Licence Number	L8308/2008/2
Licence Holder	CITIC Pacific Mining Management Pty Ltd
ACN	119 578 371
File Number:	DER2014/000430-2
Premises	Sino Iron Project Mine Site Mining Tenements M08/123, M08/124, M08/125, M08/264, M08/265, M08/266, G08/54 and L08/126 MARDIE WA 6714
Date of Amendment	15/11/2019

Amendment

This notice is limited only to modifications for Categories 5, 57 and 64. The modifications result in amendments to the authorised Category 64 throughput and locations of the Landfill and Category 57 Used Tyre Storage Facility at the Premises and a trial for the Category 5 Mill Line 6 magnetic separation elutriation columns.

Figure 1: Concentrator Process Flow Diagram

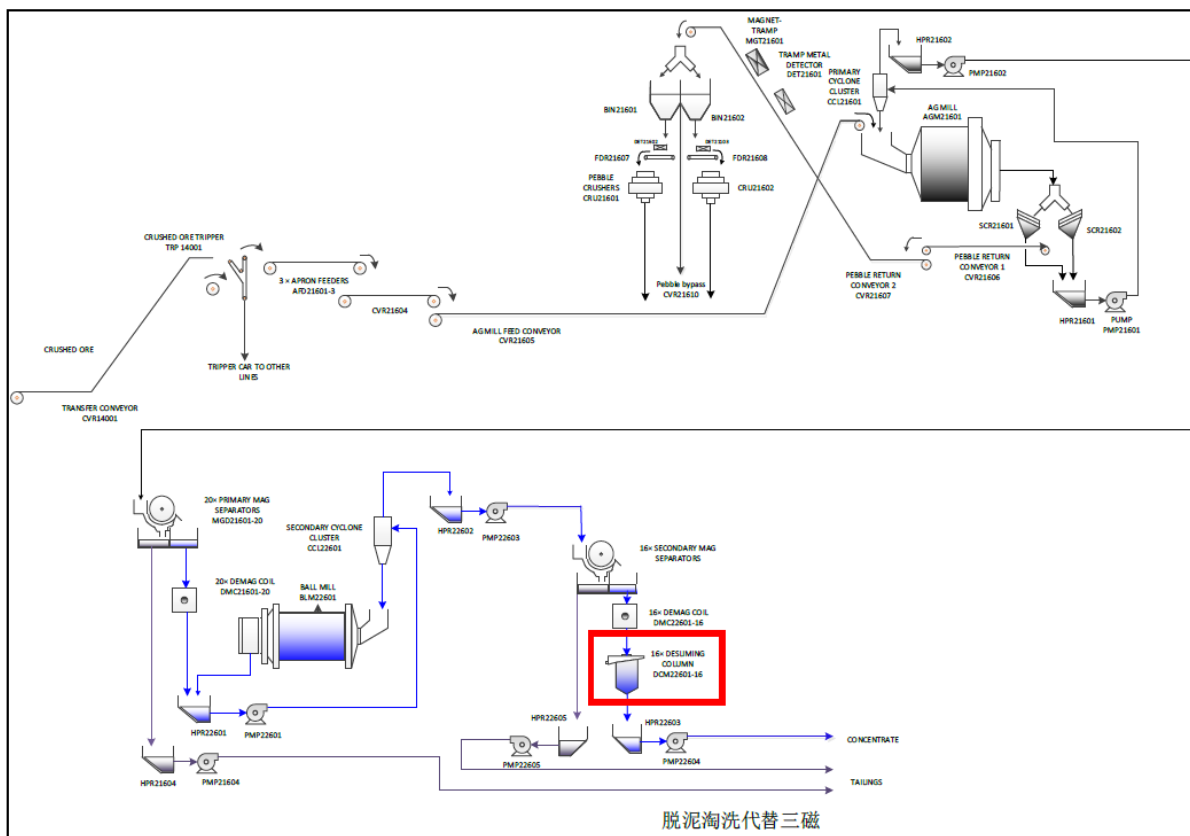
The Licence Holder is proposing to replace the third stage magnetic separator drums on Mill Line 6 with magnetic separation elutriation columns as a trial.

The reason behind this is that, as the mine pit expands the magnetite grain size becomes finer and the grind size, therefore, needs to be finer to meet the target concentrate grade of 65%. This means that the mill speed needs to be lowered with increased power consumption and operating costs.

The magnetic separation elutriation columns will be located within the existing hardstand, with no discernible variation to the composition of tailings (only slightly coarser).

The Delegated Officer has determined that it is acceptable to replace the third stage magnetic separator drums on Mill Line 6 with magnetic separation elutriation columns as a trial.

5. The maps in Schedule 1 are replaced with the following combined map:

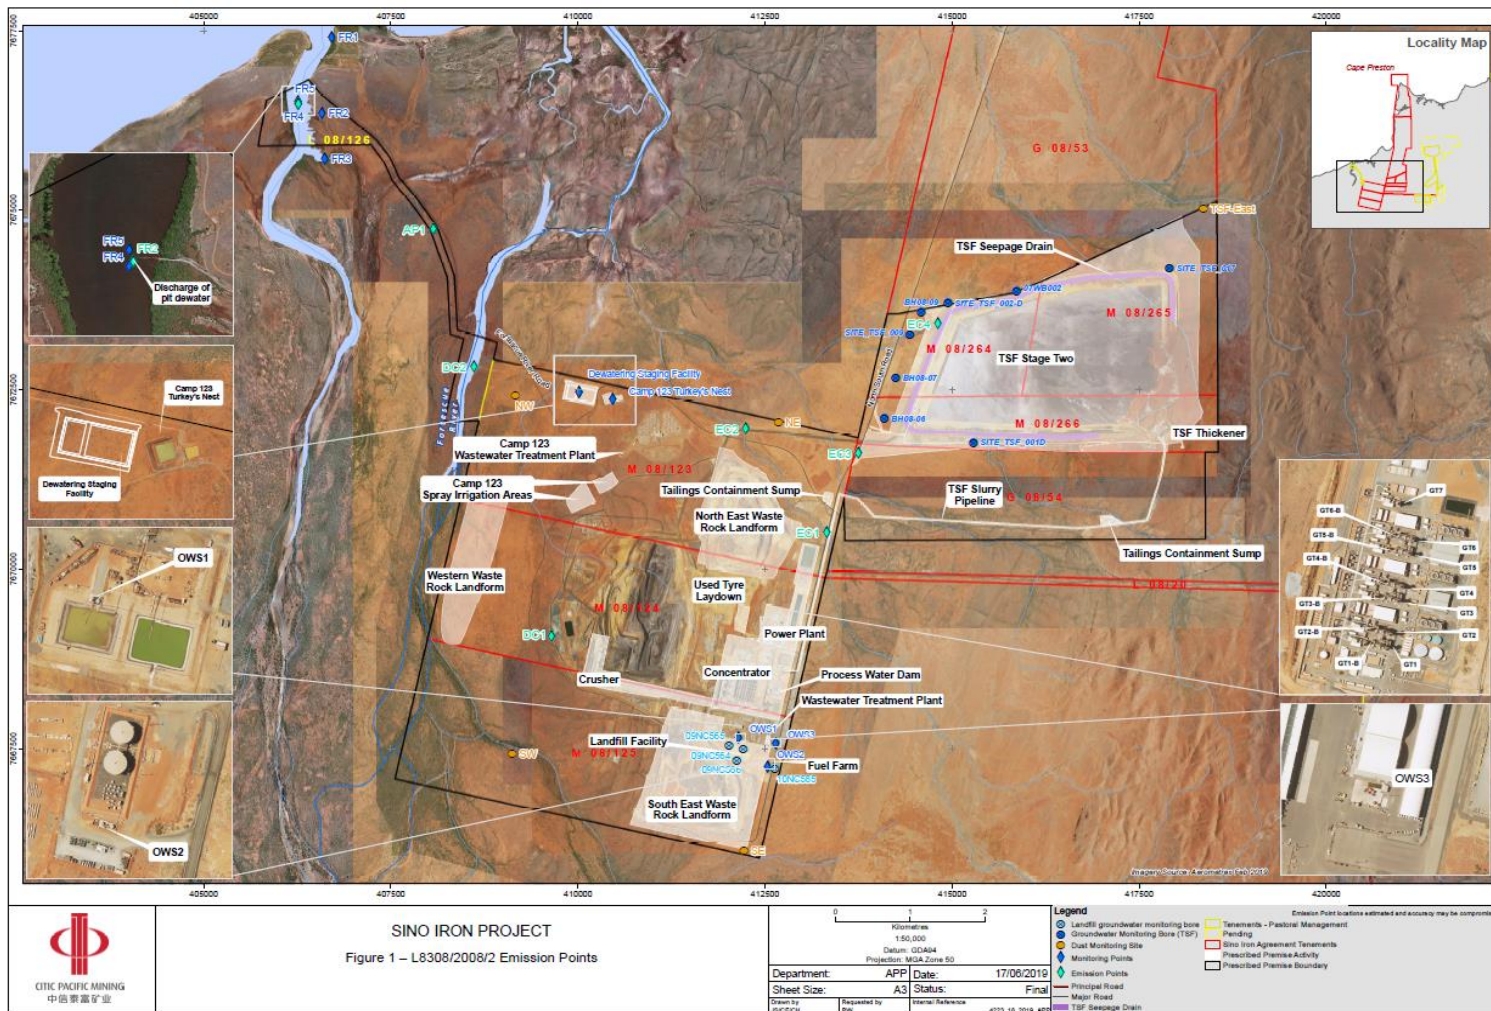
The maps in Schedule 1 have been updated to include the new Used Tyre Storage Facility location.

The maps in Schedule 1 have been updated to include the new Landfill within the South East Waste Rock Landform location.
